**2009 ERRATA
 to the**

2008 Edition of

the *SPECIAL DESIGN PROVISIONS FOR WIND AND SEISMIC, ANSI/AF&PA SDPWS-2008*
 (printed version dated 09-09 1M)

**Staggered row of fasteners
 at panel edge**

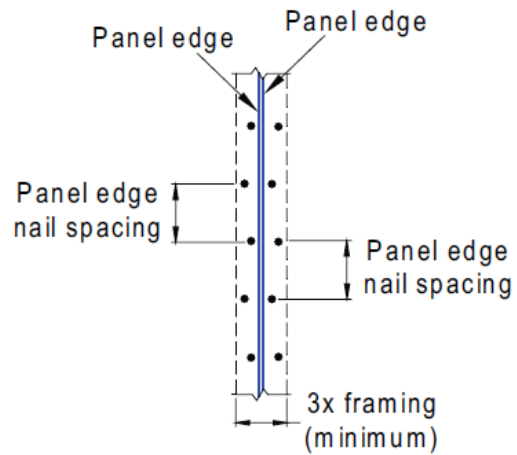
Replace Figure C4.2.7.1.1(3) with the following (printed version graphic lines too faint):
